# Access Compliance Report

## Public Rights-of-Way

| Intersection ID: 12874                  | Main Street: JACKSON_AV | Cross Street: PIEDMONT_ST               | Location: SW           |
| ADA ID: 9A4223A6ACD6                    | Ramp Type: BlendTrans2  | Initial Pass/Fail: Pass                 | Overall Compliance: No |

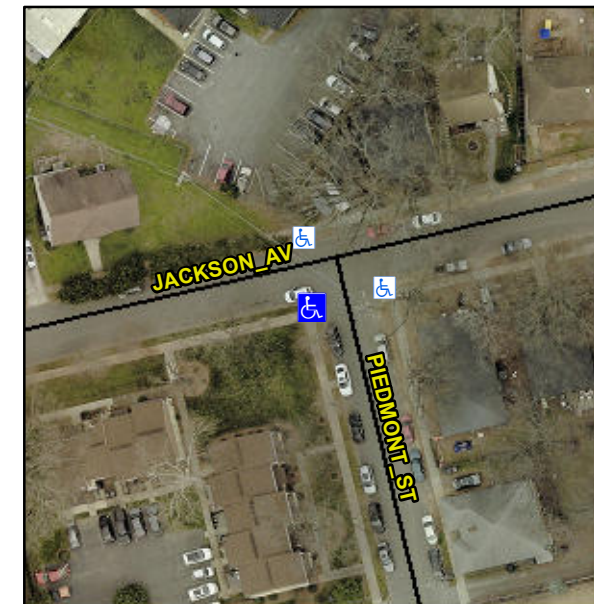
**R304.5.3, R302.7, R302.7.2**

| Compliance | Description           | Data   | Compliance | Description                 | Data   |
|------------|-----------------------|--------|------------|-----------------------------|--------|
| Yes        | Ramp Width (in)       | 48.0   | No         | BlendTrans XSlope (%)       | 3.6    |
| No         | Gutter Ponding?       | Yes    | Yes        | Gutter Slope (%)            | 2.1    |
| No         | Gutter Lip Ht (in)    | 0.5    | Yes        | Gutter X Slope (%)          | 1.6    |

**Remove & Replace Curb Ramp With Two New Directional Ramps or Equivalent. Grind Gutter Lip.**
